THE INITIAL SAE PUBLICATION OF THIS DOCUMENT WAS TAKEN DIRECTLY FROM U.S. MILITARY STANDARD MS9705A, AMENDMENT 1, NOTICE 1. THIS SAE STANDARD MAY RETAIN THE SAME PART NUMBERS ESTABLISHED BY THE ORIGINAL MILITARY DOCUMENT.

(UNS N07001), .1900-32 UNJF-3A

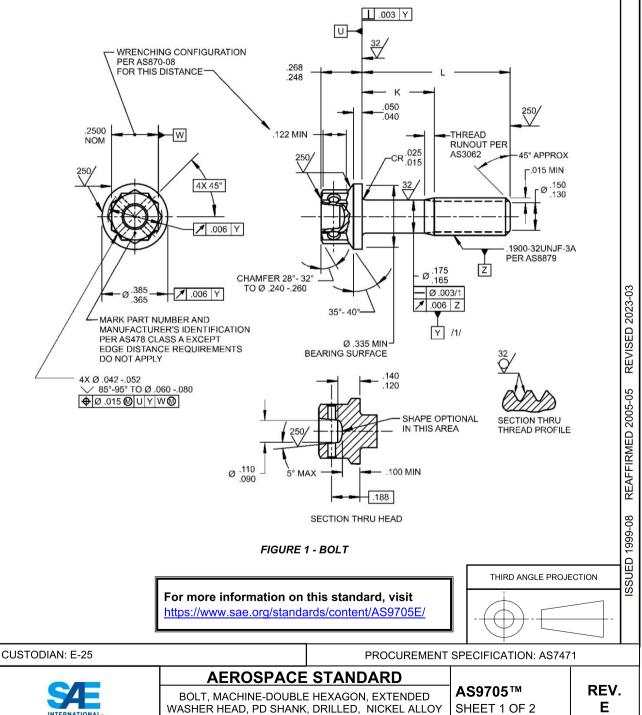
UPDATE TO ASME Y14.5-2018. REVISE LEAD THREAD CHAMFER TO AS1132. REVISE DRILLED HOLE LOCATING DIMENSION TO BASIC. REVISE FILLET RADIUS TO "CR." ADD TERTIARY DATUM ("Y") TO FCF FOR DRILLED HOLE CALLOUT PER AS1132. ADD "COMPOSITION SIMILAR TO" TO NOTE 2. GENERAL EDITORIAL REVISIONS.
